User Registration

PCN Date: 4/16/2013		Effective Date: 7/19/2013						
Title: Add assembly site for EM357 / EM351								
Originator: KF Lee	Phone: 65 6511 6428	Dept: SLI QA						
Customer Contact: Kathy Haggar	Phone: 1-512-532-5261	Dept: Sales						
PCN Type: <input type="checkbox"/> Datasheet <input type="checkbox"/> Foundry <input type="checkbox"/> Packing <input type="checkbox"/> Product Revision <input checked="" type="checkbox"/> Assembly <input type="checkbox"/> Labeling <input type="checkbox"/> Discontinuance <input type="checkbox"/> Test <input type="checkbox"/> Other								
Last Order Date: Not Applicable.								
PCN Details								
Description of Change: Silicon Laboratories is pleased to announce the successful qualification of a second assembly site, ASE Chung Li, Taiwan (ASECL), for EM357 and EM351 products. Product assembled at ASECL will have a different marking from the product assembled at the original assembly site, Stats Chippac Malaysia (SCM). Please see Appendix A for details of the marking differences. There is a slight difference in the dimensions of the package from ASECL, however packages from both assembly sites fall within the JEDEC specification for

POD for ASECL 48QFN 7x7

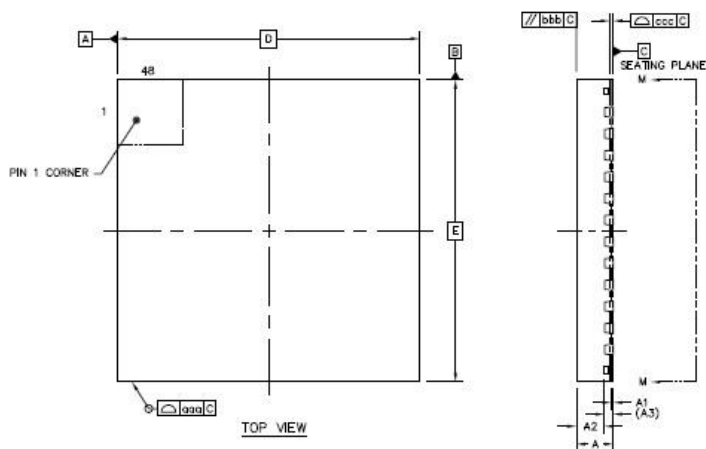
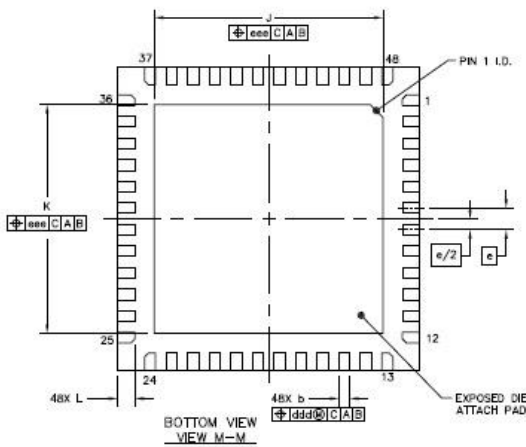
Package type	SCM 48QFN 7x7			ASECL 48QFN 7x7		
Dimensions	Minimum (mm)	Maximum (mm)	Nominal (mm)	Minimum (mm)	Maximum (mm)	Nominal (mm)
Package thickness	0.80	1.00	0.90	0.80	0.90	0.85
Lead Length	0.40	0.60	0.50	0.35	0.45	0.40
